**COLCHESTER TOWN GREEN BICYCLE & PEDESTRIAN IMPROVEMENT PROJECT
ADDENDUM NO. 2
SEPTEMBER 10, 2021**

The following questions received from contractors form this addendum:

SITE LIGHTING
PHOTOMETRIC CALCULATION

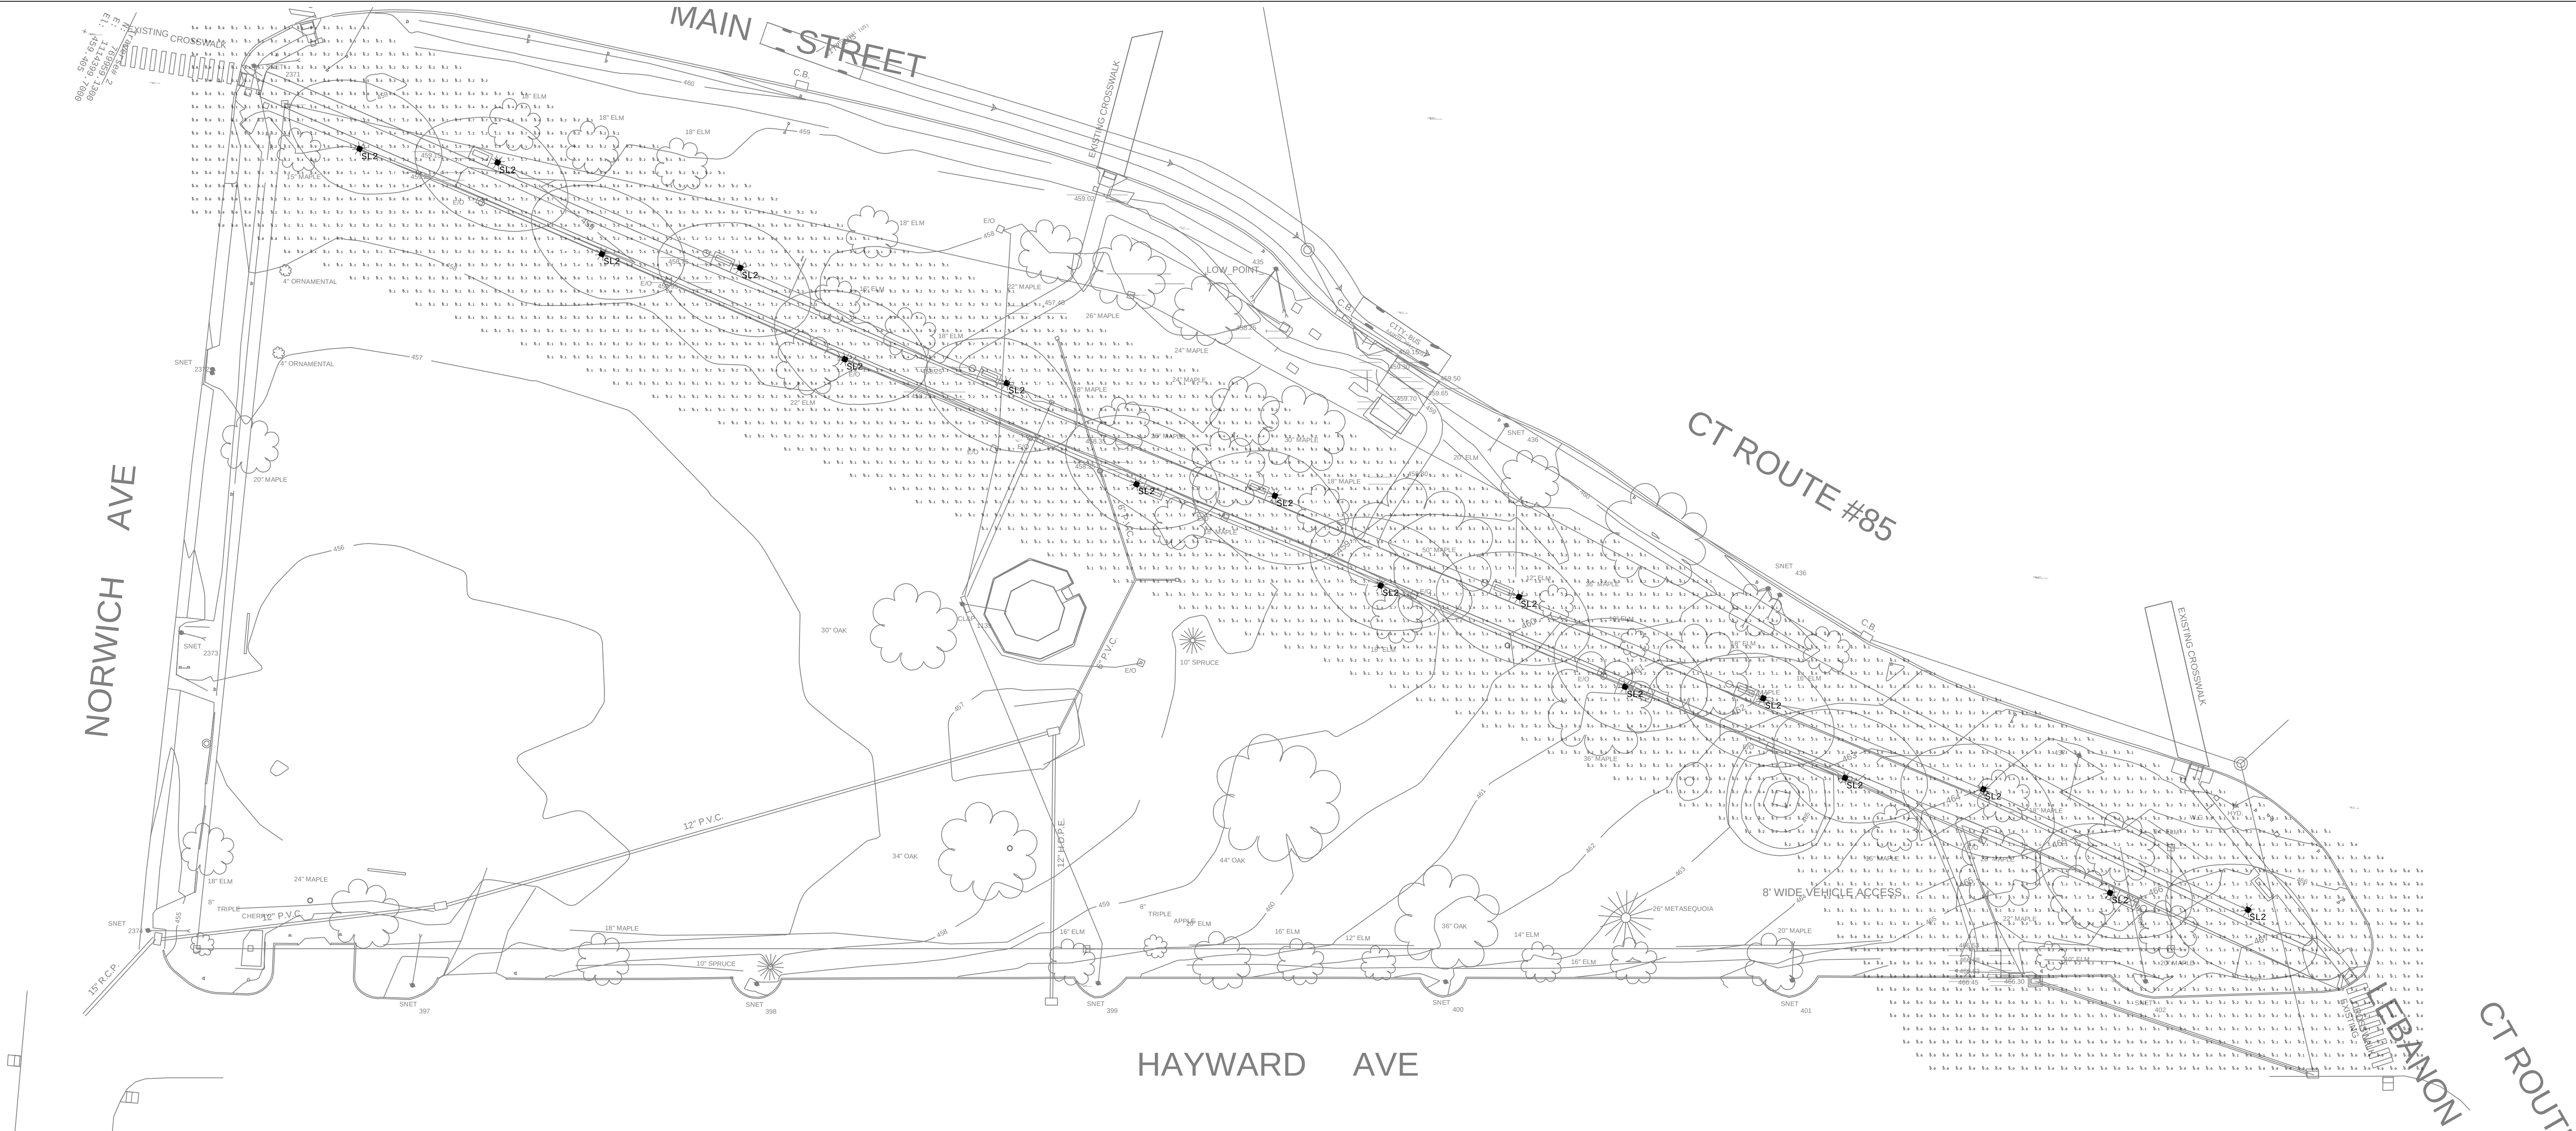
- 6. Additional light pole specifications have been provided by apex lighting solutions. The Luminaire Schedule for this project includes 16 HADCO VX151-48-G3-A-F-2-N-730-A-3-SP1-L / MOUNTED TO VI-D/INT/CI/11FT7IN-DB-WPC-3INX3IN TENON-AB poles.**

TYPICAL UG CONDUIT (SINGLE CONDUIT)

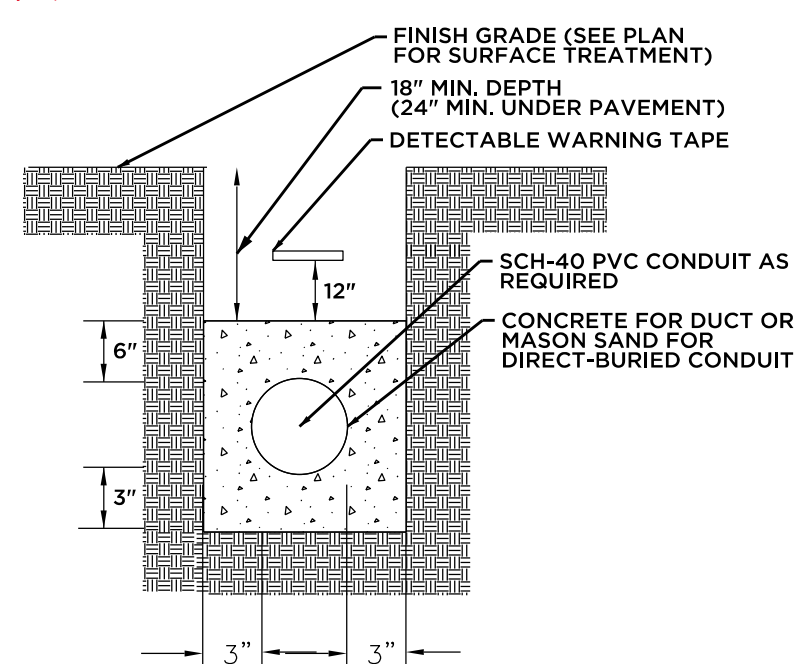
3. The detail sheet and the layout sheet seem to contradict each other regarding the electrical conduit. The layout plan states (1) two inch PVC conduit on each side of the walkway, though the detail sheet shows the conduit trench with two PVC conduit. We would like clarification on the amount of PVC piping and the locations.

Response: *See the attached revised detail sheet. The revised detail sheet includes a detail for a single underground conduit for areas along either side of the pathway, as well as a detail for multiple underground conduits for the area connecting the conduits along the path to the electrical service connection box.*
